## 18/1081/RES | Development for 101 dwellings at Wear Barton Road Exeter

The Exeter Cycling Campaign welcomes the chance to comment on the proposed [development at Wear Barton Road, Exeter](#).

Fig 1.

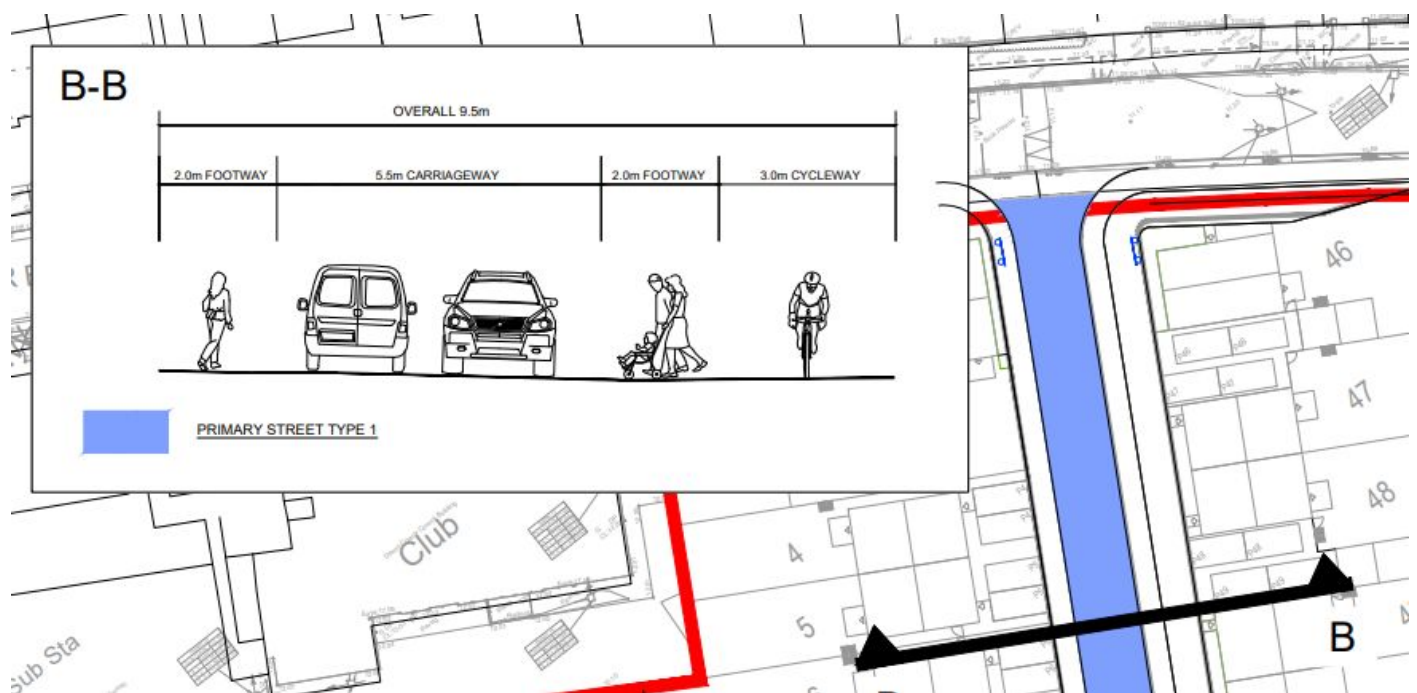
The drawing [VD18691-RM-103 Roads Hierarchy Plan](#) shows the primary street widths and proposed allocation of space. The primary street is shown with an allocation of space to people walking (2x 2m=4m), people cycling (3m) and people driving (5.5m): a total of 12.5m. This, the plan suggests, will be fitted into an overall width of 9.5m. Clearly this is incorrect.

This suggests that insufficient thought has been put into this space allocation. The Campaign would suggest that for this development, which is so close to the city centre and whose design should therefore strongly prioritise cycling/walking, the primary street should enable people walking and cycling as the primary means of movement. This should be done by disallowing parking on this primary street, having 'build out' trees/shrubs and, because this street should be lightly trafficked, the road markings should have designated

cycle paths with the car-width less than two car widths. This design should be taken through the entire length of the primary street.

Fig 5: Extend the cycle path along the southern part of Wear Barton Road so that the strong desire line to connect up directly with Riverside Walk in Topsham.

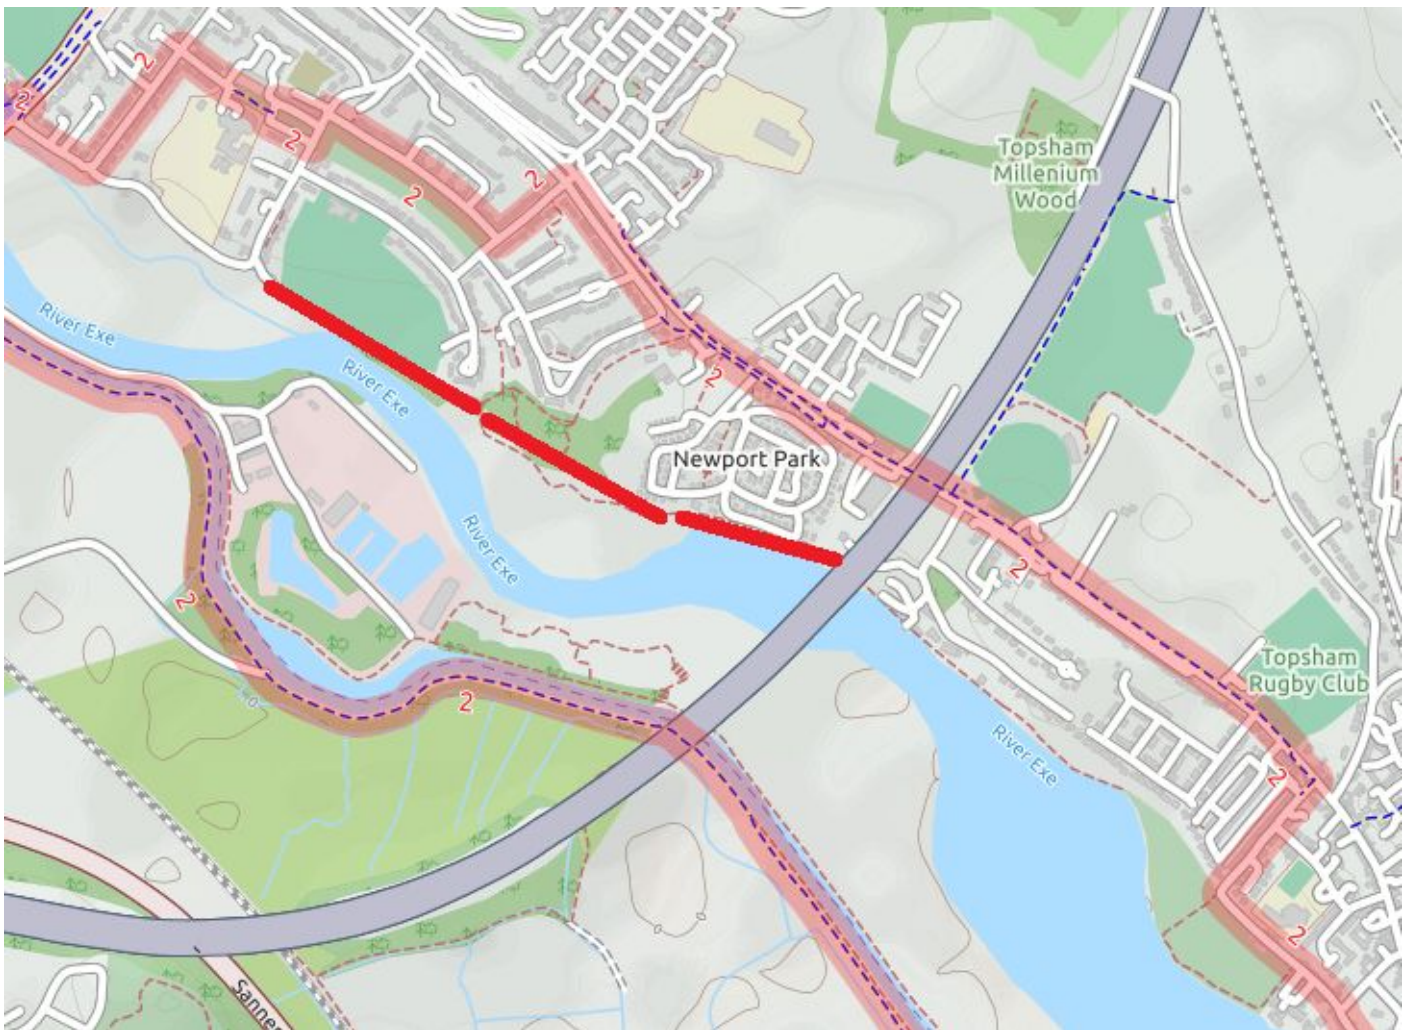
This development provides the opportunity to give focus and developer-contribution to extending the 'Route 2' cycle path. This currently heads inwards along Glasshouse Lane to Lakeside Avenue. The 'desire line' for people cycling is clearly continuing beside the River Exe at the south of this proposed development so that the cycle path is more direct and connects up with the Riverside Walk in Topsham.
